Title	Noise response to ISH5 and documentation review			
Project	Gatwick Airport DCO			
Reference	28AD.NT.2.1	Author(s)	ВНо	
Date	22 March 2024	Reviewer	VC

# 1.0 Post-Hearing Submissions

#### 1.1 Introduction

Figure 1: Proposed and Extant Noise Insulation Schemes

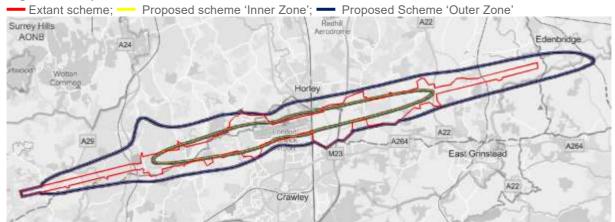
- 1.9.1 The proposed scheme would lead to reduced funding and insulation choice being available at a number of locations. Suono have been able to overlap the two figures on Figure 14.8.1, which is shown on Figure 1 below.
- 1.9.2 The Outer Scheme is actually divided into three zones, each with different funding levels, as set out in section 4.1.11 of Appendix 14.9.10 Noise Insulation Scheme [APP-180]. The lowest level of funding available is £3,500 (54 dB to 57 dB  $L_{Aeq,16hour}$ ), which is less than the £4,300 currently offered as part of the scheme. There is also only a small improvement financially to those within the next zone up to £5,000 (57 dB to 60 dB  $L_{Aeq,16hour}$ ).
- 1.9.3 Dwellings in the Outer zone will now only be offered acoustic ventilators, rather than the current offer of glazing, which may constitute another disbenefit depending on the property.

- 1.9.4 The figures provided by the Applicant include coloured highlighting around the Zones and the actual extent of the zones is not clear.
- 1.9.5 The Applicant indicated in ISH5 that changes are to be made to the Noise Insulation Scheme; we await these updates and expect the points made within this note to be addressed.
